JV10-NL Block Diagram

Project code: 91.4HX01.001
PCB P/N : 48.4HX01.0SB
REVISION : SB

Title: **Modify History**

Date: Sunday, January 31, 2010 Sheet 42 of 42

Title: **LCD Conn**

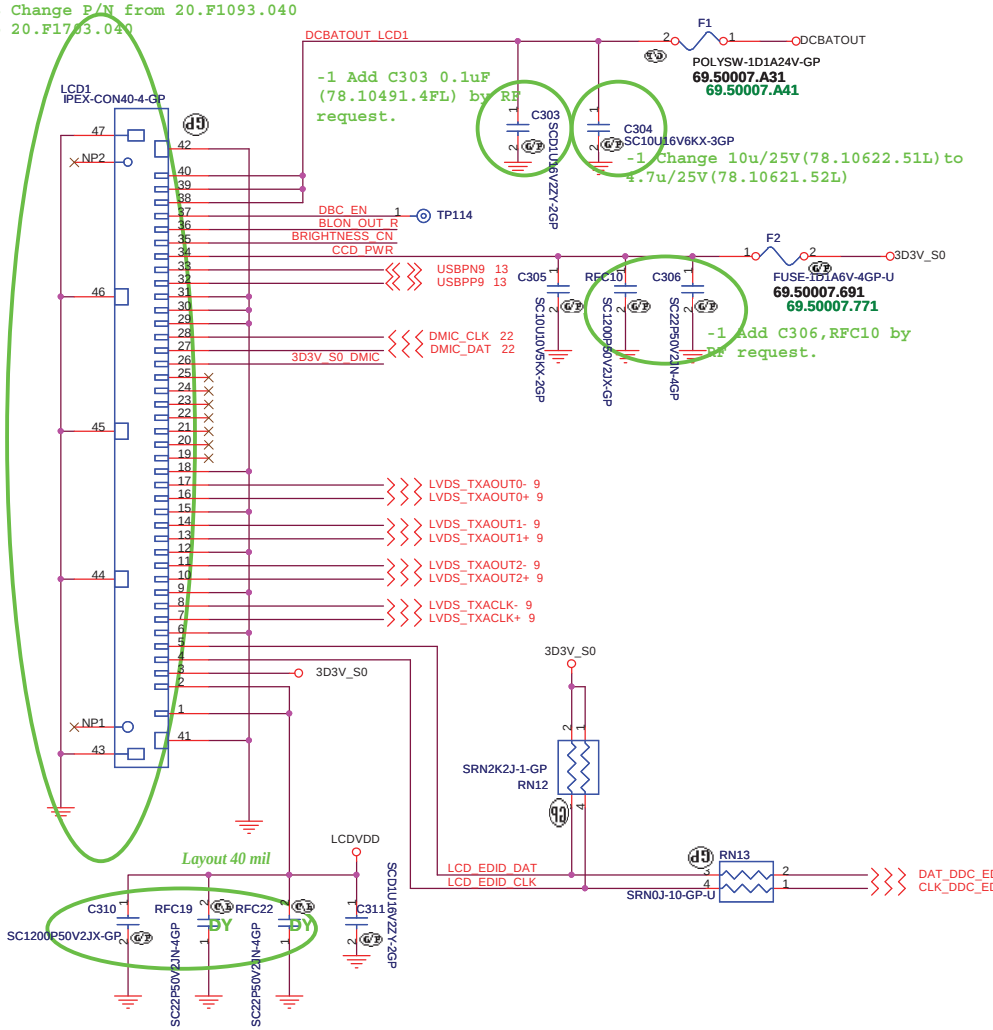
SB Change P/N from 20.F1093.040
to 20.F1703.040

Title	LAN CONN	
Size A3	Document Number SJV10-NL	Rev -1
Date: Tuesday, January 26, 2010	Sheet 24 of 42

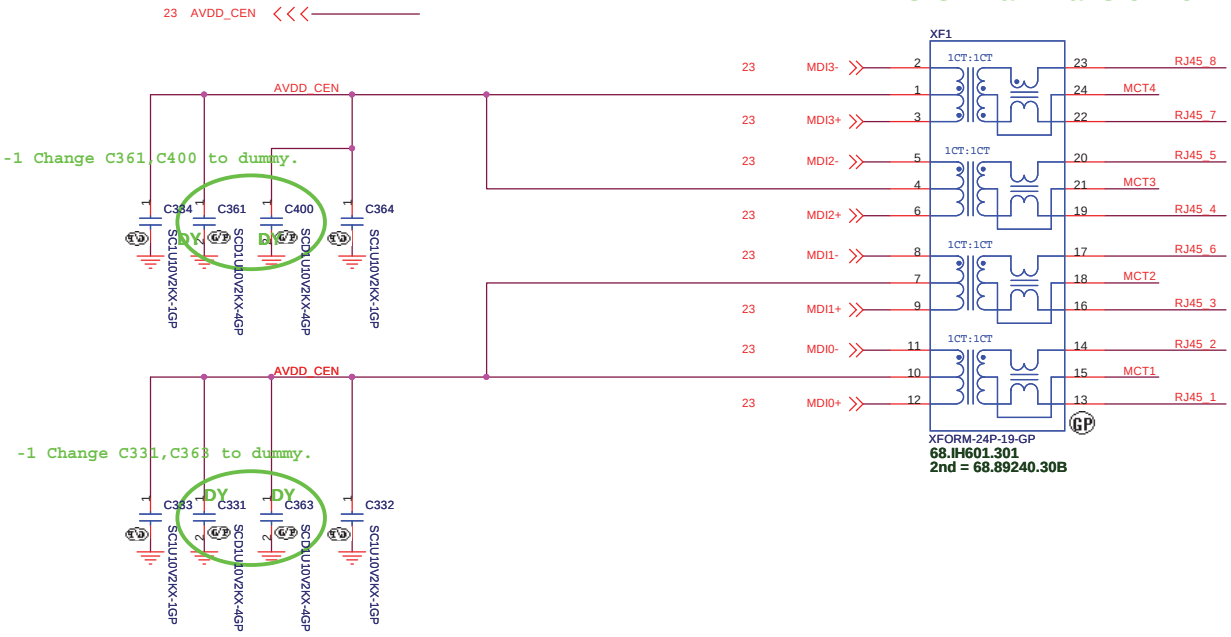
-1 Change R832,R833 to RN143.

SB change P/N form 78.1022S.24L to 78.1022S.L1L

緯創資通 Wistron Corporation 21F, 88, Sec.1, Hsin Tai Wu Rd., Hsichih, Taipei Hsien 221, Taiwan, R.O.C.		
Title: LED_CARD reader		
Size: A2	Document Number: SJV10-NL	Rev: -1
Date: Monday, February 01, 2010	Sheet 25 of 42

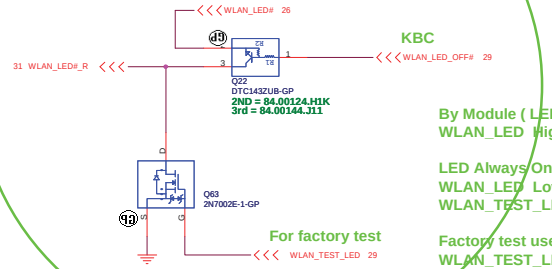
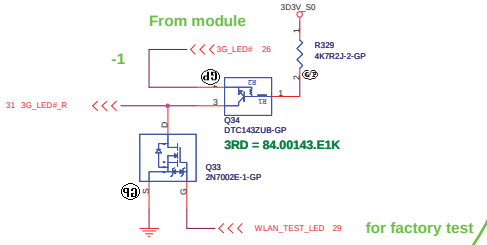
SB Change LED portion connection

-1 Change 3G LED portion circuit

SB change P/N to 20.I0087.011

-1 change Card1 P/N to 62.10024.B41

Mini Card Connector(3G)

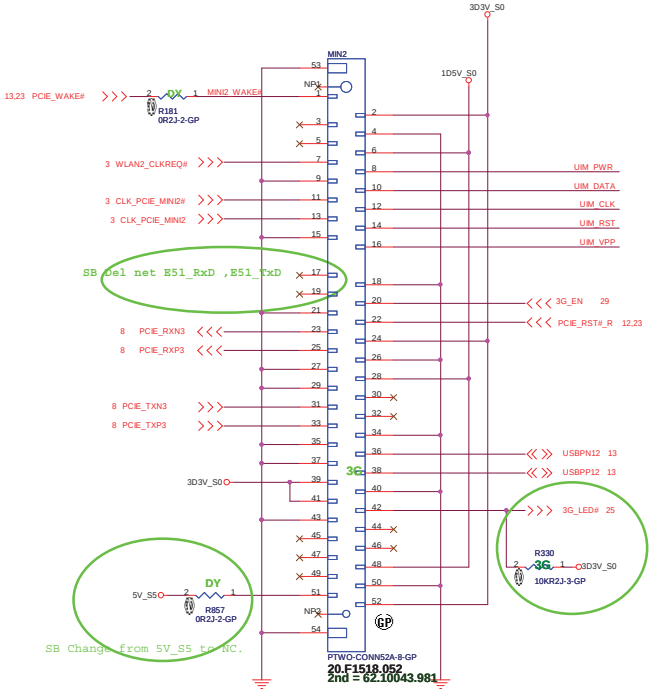
-1 Change C357 to DY.

Sheet 28 of 42

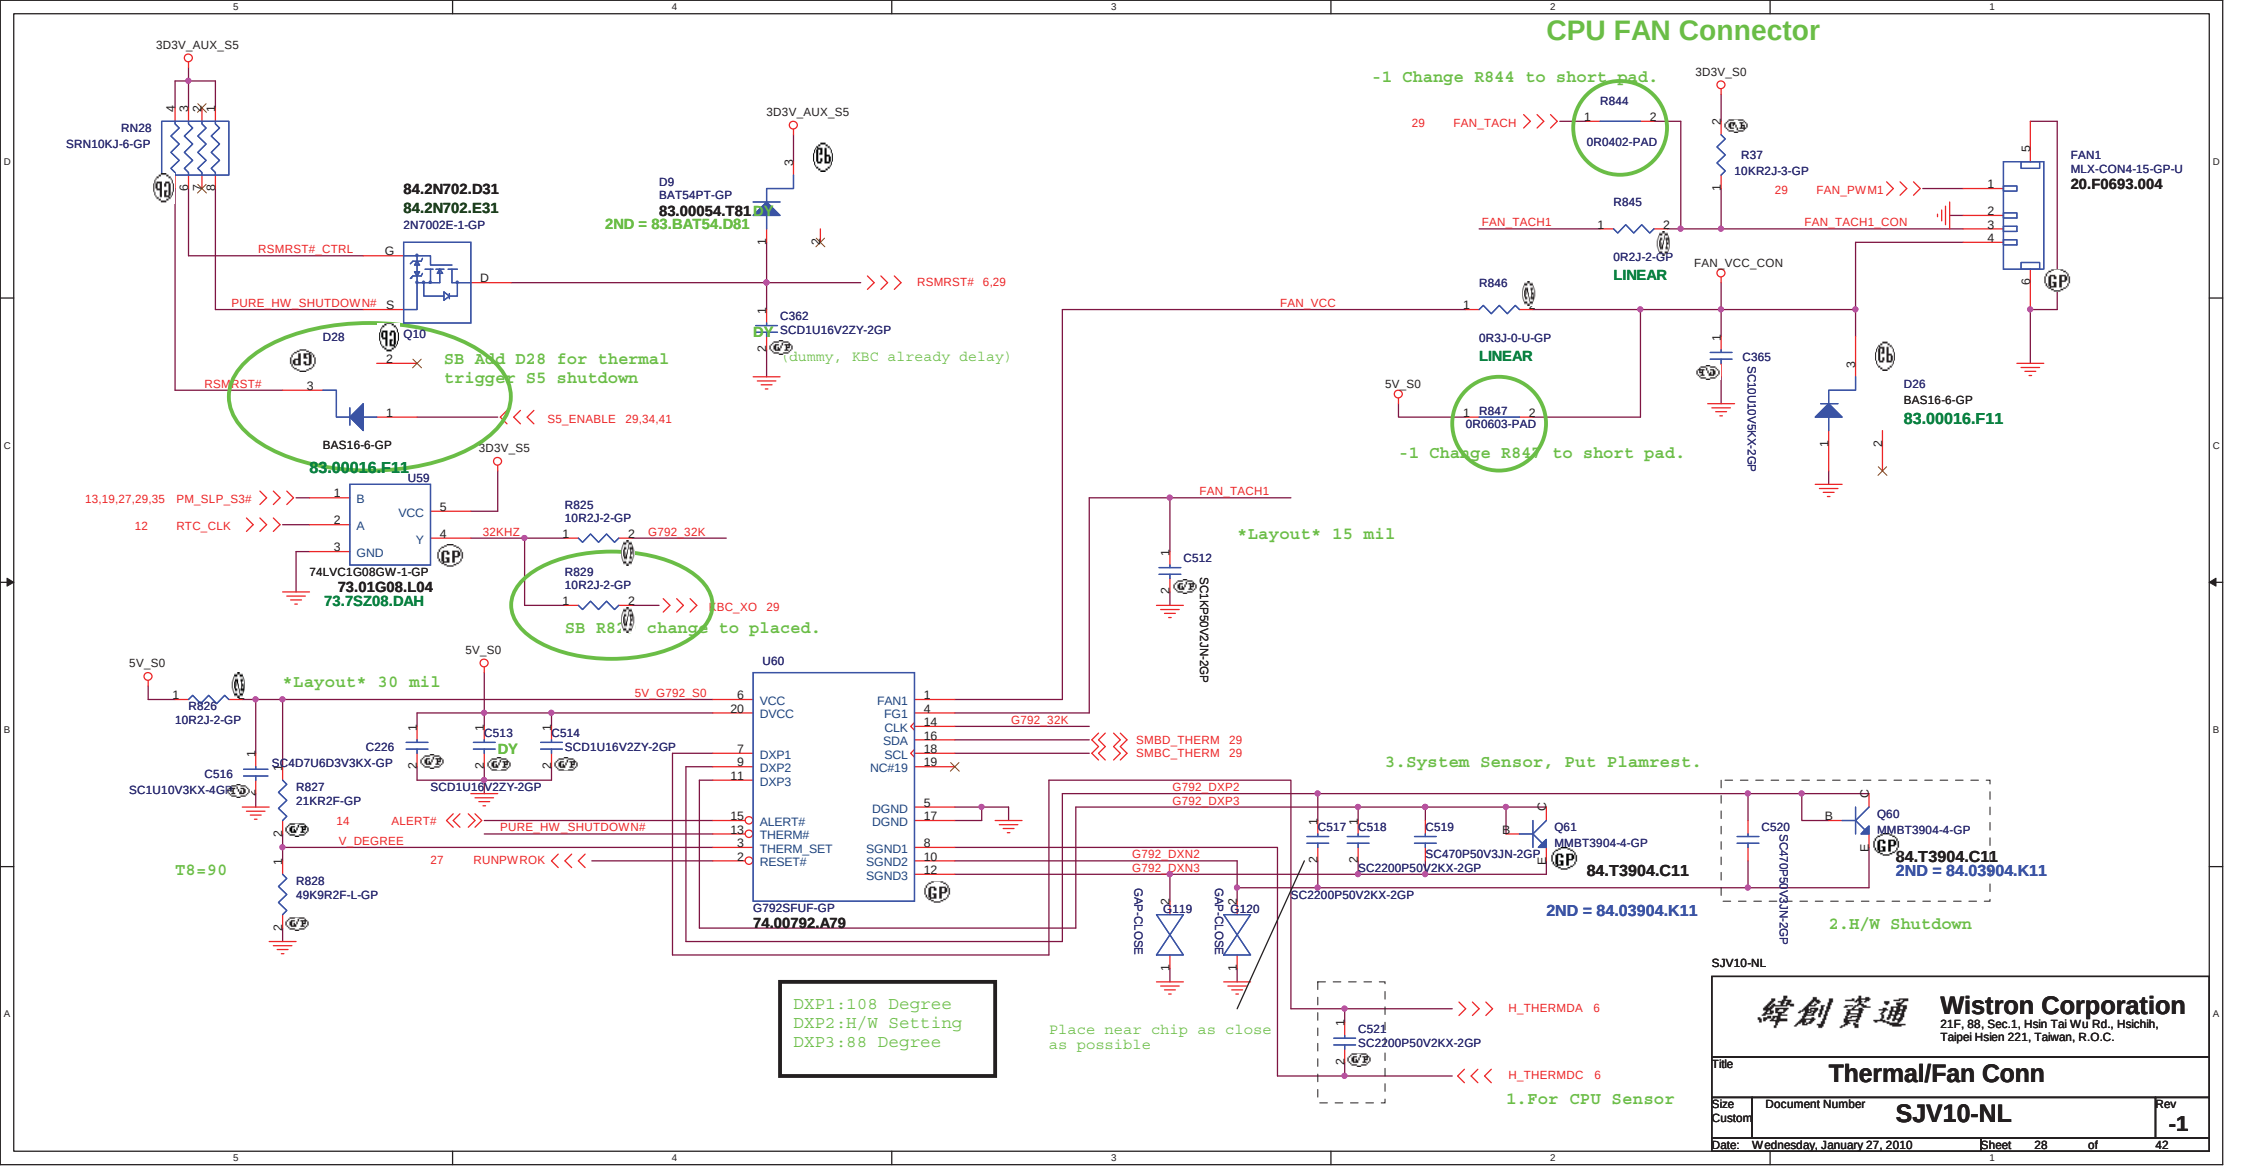
CPU FAN Connector
-1 Change R844 to short pad.
3D3V_AUX_S5
RN28
SRN10KJ-6-GP
84.2N702.D31
84.2N702.E31
2N7002E-1-GP
RSMRST#_CTRL
PURE_HW_SHUTDOWN#
D28
Q10
SB Add D28 for thermal trigger S5 shutdown
RSMRST#
BAS16-6-GP

20.F0693.004
R845
FAN_TACH1
0R2J-2-GP
LINEAR
FAN_TACH1_CON
FAN_VCC_CON
FAN_VCC
R846
0R3J-0-U-GP
LINEAR
C365
SC10U10V5KX-2GP
5V_S0
R847
0R0603-PAD
-1 Change R847 to short pad.
D26
BAS16-6-GP

83.00016.F11
U59
13,19,27,29,35 PM_SLP_S3#
12 RTC_CLK
74LVC1G08GW-1-GP
73.01G08.L04
73.7SZ08.DAH
R825
10R2J-2-GP
32KHZ
G792_32K
R829
10R2J-2-GP
KBC_XO 29
SB R829 change to placed.
FAN_TACH1
Layout 15 mil
C512
SC1KP50V2JN-2GP
Layout 30 mil
R826
10R2J-2-GP
5V_G792_S0
C226
SC4D7U6D3V3KX-GP
C513
DY
C514
SCD1U16V2ZY-2GP
SCD1U16V2ZY-2GP
C516
SC1U10V3KX-4GP
R827
21KR2F-GP
R828
49K9R2F-L-GP
T8=90
14 ALERT#
V_DEGREE
27 RUNPWROK
PURE_HW_SHUTDOWN#
U60
VCC
DVCC
DXP1
DXP2
DXP3
ALERT#
THERM#
THERM_SET
RESET#
DGND
DGND
SGND1
SGND2
SGND3
FAN1
FG1
CLK
SDA
SCL
NC#19
G792SFUF-GP

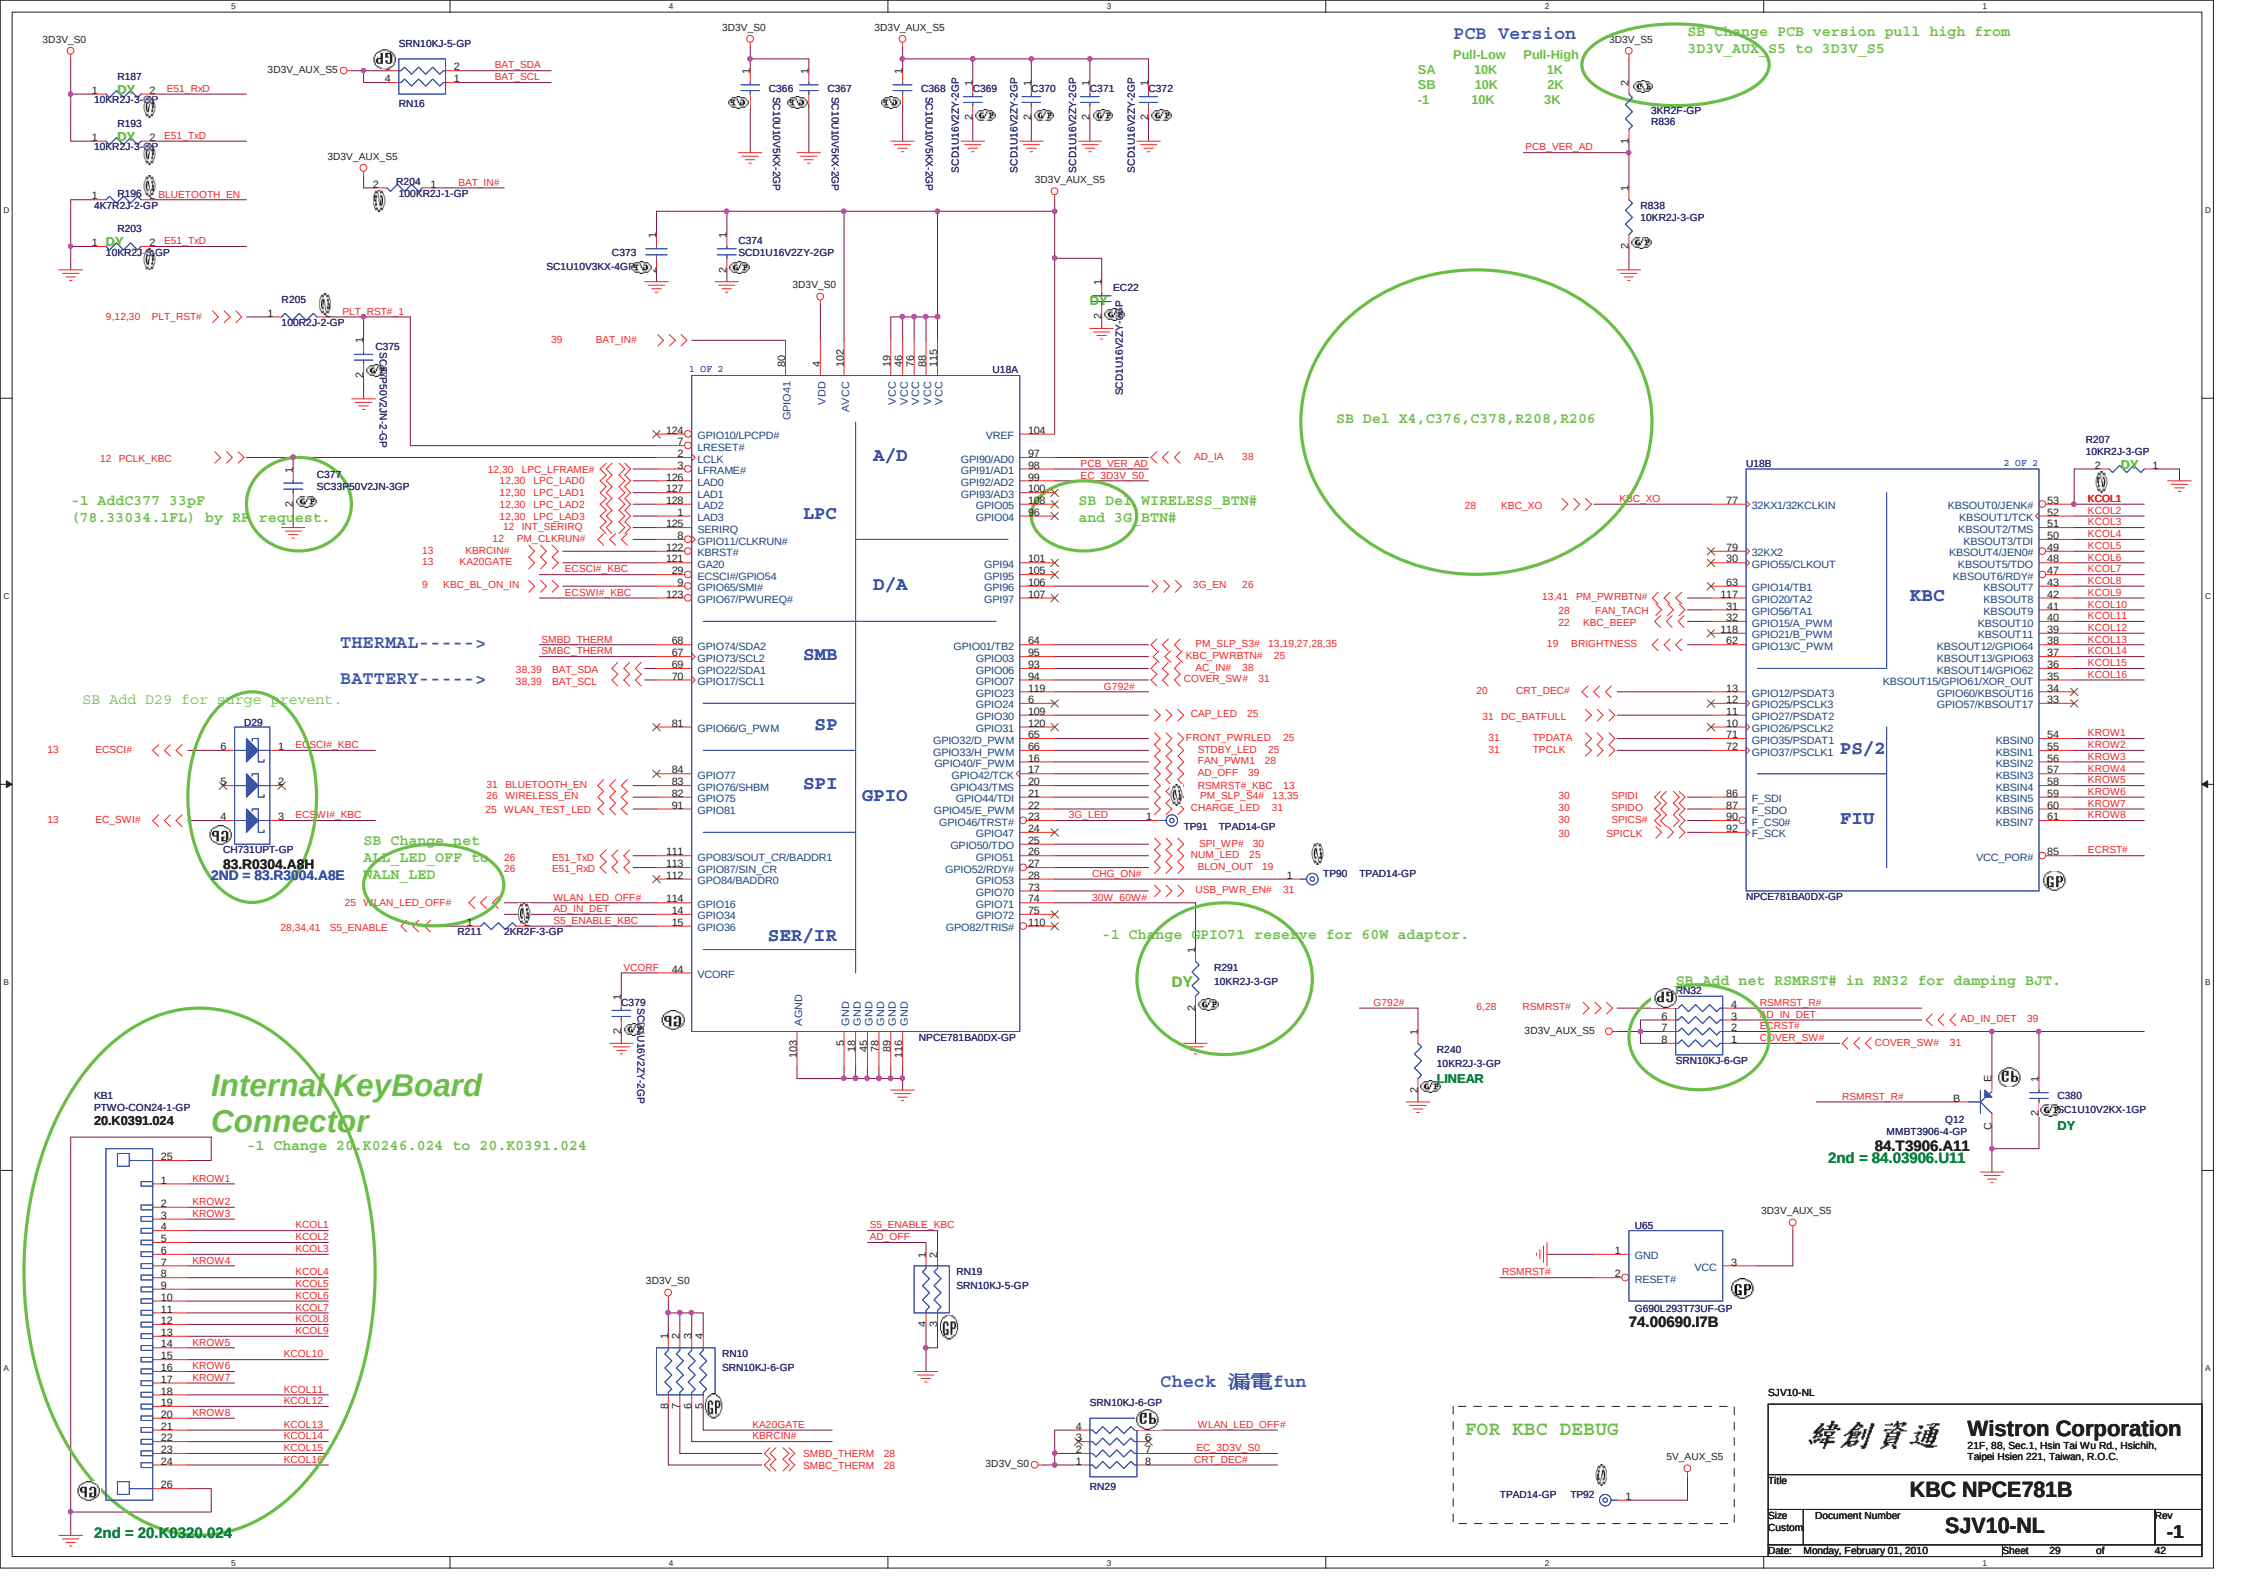
PCB Version
Pull-Low Pull-High
SA 10K 1K
SB 10K 2K
-1 10K 3K
SB Change PCB version pull high from 3D3V_AUX_S5 to 3D3V_S5
SB Del X4,C376,C378,R208,R206
SB Del WIRELESS_BTN# and 3G_BTN#
-1 AddC377 33pF (78.33034.1FL) by RF request.
SB Add D29 for surge prevent.
SB Change net ALL_LED_OFF to WALN_LED
-1 Change GPIO71 reserve for 60W adaptor.
SB Add net RSMRST# in RN32 for damping BJT.
Internal KeyBoard Connector
-1 Change 20.K0246.024 to 20.K0391.024
2nd = 20.K0320.024
Check 漏電fun
FOR KBC DEBUG
THERMAL------>
BATTERY------>
U18A
U18B
KBC
PS/2
FIU
LPC
A/D
D/A
SMB
SP
SPI
GPIO
SER/IR
NPCE781BA0DX-GP
Wistron Corporation
KBC NPCE781B
SJV10-NL
